Inventor: Bosse

Response to O.A. dated 02/01/2005

Amendments to the Drawings

FIG. 5A

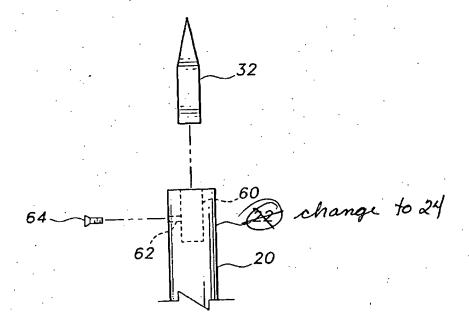
Examiner objected to FIG. 5A because reference number 22 was pointing to the incorrect

part. Upon further review of the specification and other drawings, the Applicant discovered that FIG.

5B also incorrectly utilized reference number 22. Therefore, a replacement sheet showing FIGS. 5A

and B is attached hereto, and reference 22 has been renumbered as reference number 24 in both

drawings.
